**CITY OF MERCED PROJECT NO. CP220061
CHANGE ORDER NO. 2**

PROJECT NAME: Community Park 42

Additional work to add underground electrical, water. Quantity adjustment for additional asphalt per the contract unit price.

DR. BY: TF / YC
DATE: 01/12/2023
CH. BY: SK/CK/JN
DATE: 01/12/2023
SCALE: AS SHOWN
File No. 40320-UP.DWG
Sheet
C2.1
22 of 75

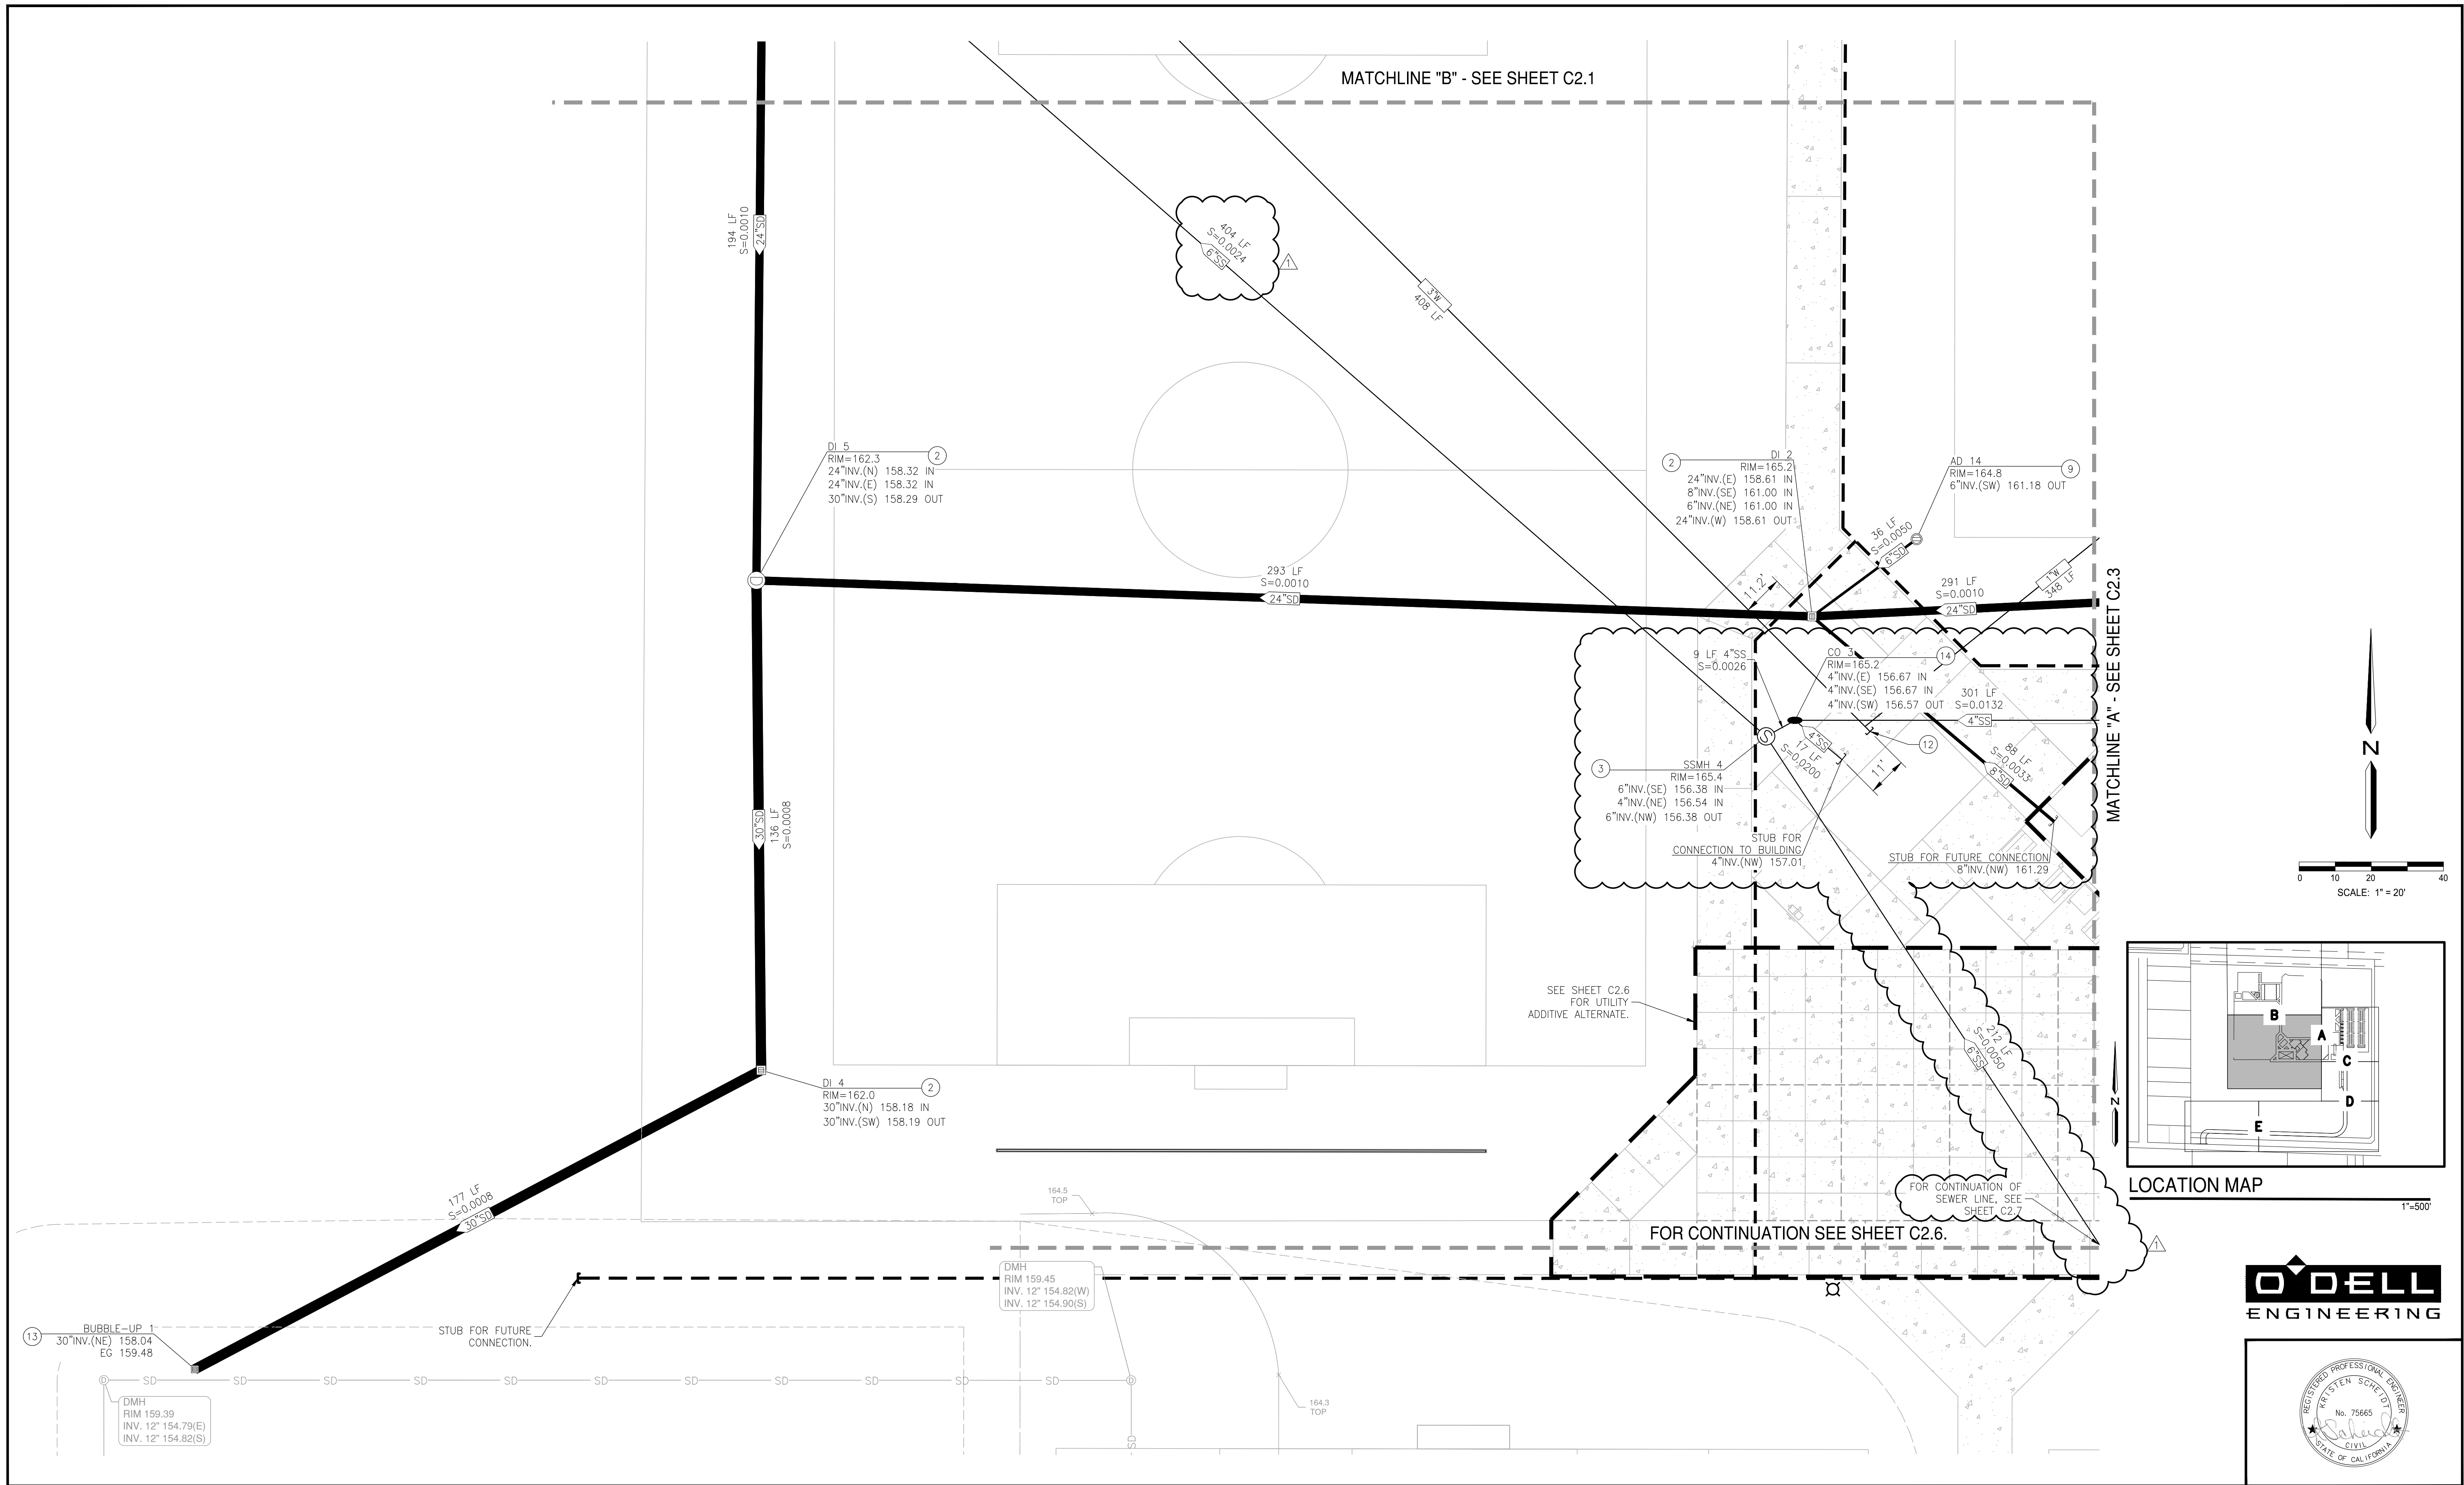
REQUEST: Bid Item # 23 - 6" Sewer shows a quantity of 1,170 LF. When we preformed our take off, we found 2,830LF shown on the plans. That's an additional 1,660LF. Please verify quantities.

REPLY: See sheets C2.1 to C2.5 and C2.7 to C2.8 Rev 1 dated 8/16/23 showing revised sewer line routing between concession building and well site 20. Line item 23 on Bid Schedule A to be updated to 2,561 LF.

DR. BY: TF / YC	File No. 40320-UP.DWG
DATE: 01/12/2023	Sheet
CH. BY: SK/CK/JN	<div style="font-size: 48pt; font-weight: bold;">C2.5</div> <div style="font-size: 24pt; font-weight: bold;">26 of 75</div>
DATE: 01/12/2023	
SCALE: AS SHOWN

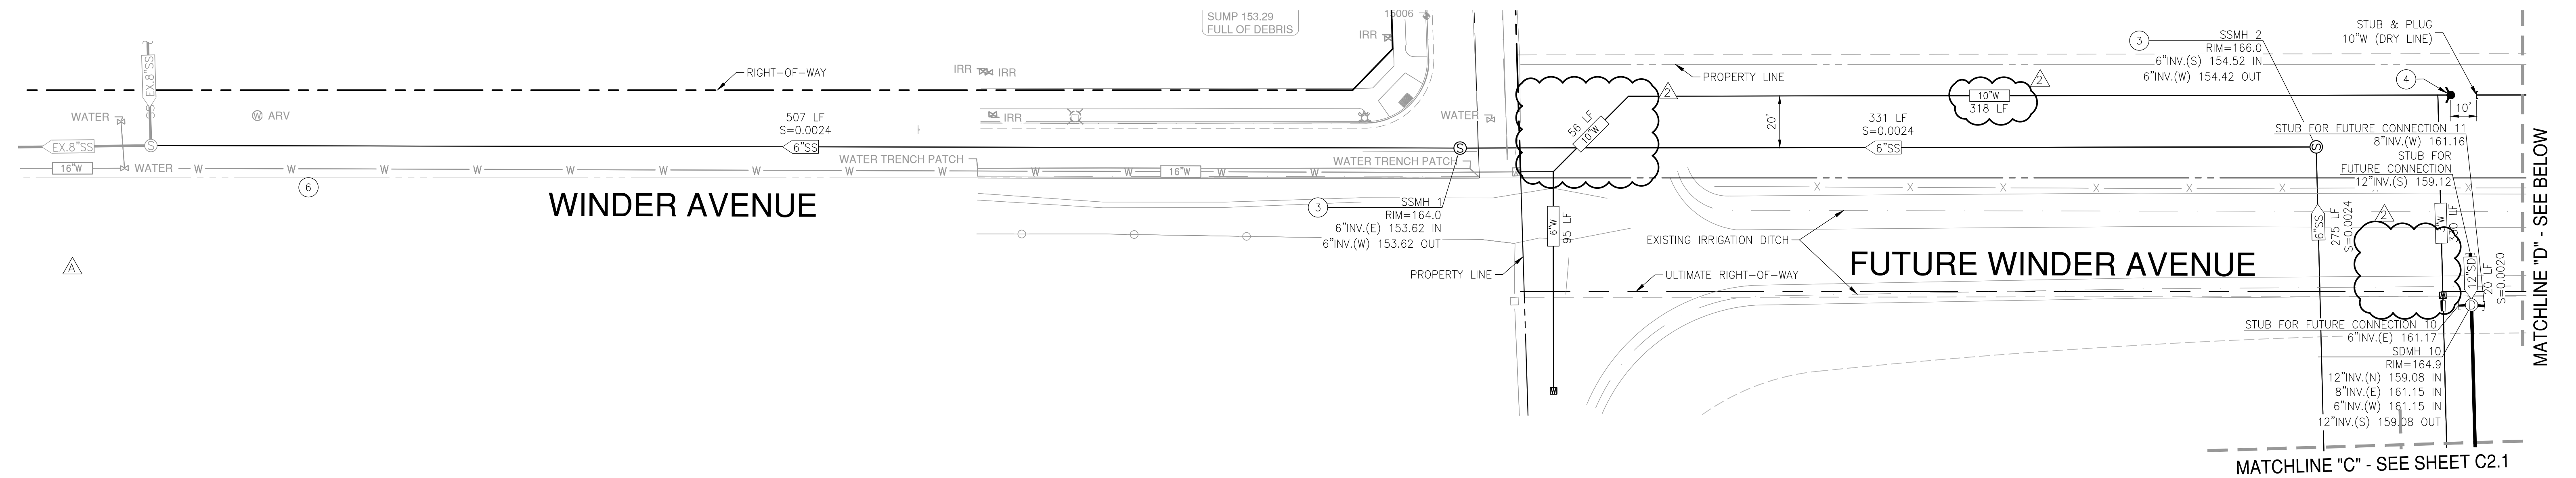
REQUEST: Bid Item # 33 - 10" Water Line (Offsite) shows a quantity of 1,780 LF. When we preformed our take off, we found 1,290 LF shown on the plans. That's 490 LF less than shown for the bid item. Please verify quantities.

REPLY: Upon review of the bid documents, there is 1,281 LF of 10" water line along Winder. See attached sheet C2.5 revision 2 for revised pipe sizes. Line item 22 on Bid Schedule A to be revised to 1,281 LF.
